H.B. Robinson Steam Electric Plant, Unit 2
Renewed Facility Operating License No. DPR-23
Docket No. 50-261

Subject: Response to NRC Request for Additional Information (RAI) Regarding Application to Adopt 10 CFR 50.69, "Risk-Informed Categorization and Treatment of Structures, Systems, and Components for Nuclear Power Reactors"

Response to NRC Request for Additional Information (RAI) Regarding Application to Adopt 10
CFR 50.69, "Risk-Informed Categorization and Treatment of Structures, Systems, and
Components for Nuclear Power Reactors"

Figure 5-6
OTHER EXTERNAL HAZARDS

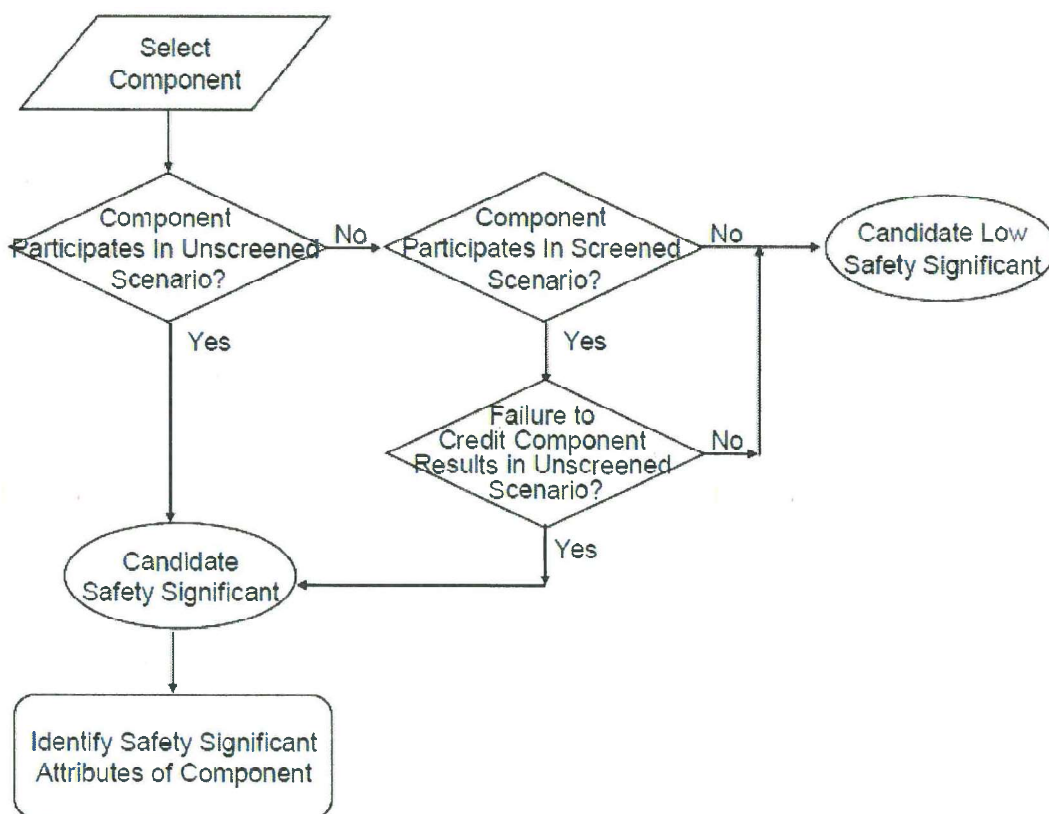
As part of the categorization assessment of other external hazard risk, an evaluation is performed to determine if there are components being categorized that participate in screened scenarios and whose failure would result in an unscreened scenario. Consistent with the flow chart in Figure 5-6 in Section 5.4 of NEI 00-04, these components would be considered HSS. All remaining hazards were screened from applicability and considered insignificant for every SSC and, therefore, will not be considered during the categorization process.

The last sentence implies that the assessment has been completed and concludes that all other external hazards will never need evaluation during categorization. The individual plant examination of external events (IPEEE) screening process did not include the additional step illustrated in Figure 5-6 in Section 5.4 of NEI 00-04. Figure 5-6 and its associated text states that an evaluation is performed to determine if there are components being categorized that participate in screened external event scenarios whose failure would result in an unscreened scenario.

Clarify how the screening criteria in LAR Attachment 5, "Progressive Screening Approach for Addressing External Hazards," satisfy the guidelines that HSS will be assigned to SSCs whose failure would cause a screened external event scenario to become unscreened.

The screening criteria in Attachment 5 of the LAR were used to determine those external hazards listed in Attachment 4 of the LAR requiring a PRA model for this application and those

screened from needing a PRA model. The LAR Attachment 5 denotes the screening criteria that determines “screened scenarios” versus “un-screened scenarios”. Per NEI 00-04 the external hazard assessment is required for each SSC categorization. As such, each SSC being categorized will be assessed in accordance with NEI 00-04 Figure 5-6 for the external hazards listed in Attachment 4 of the LAR. If the failure of the SSC results in the screening criterion from Attachment 5 not being met, then the scenario would become unscreened and the SSC would become candidate High Safety Significant. NEI 00-04 Figure 5-6 is shown below for reference.
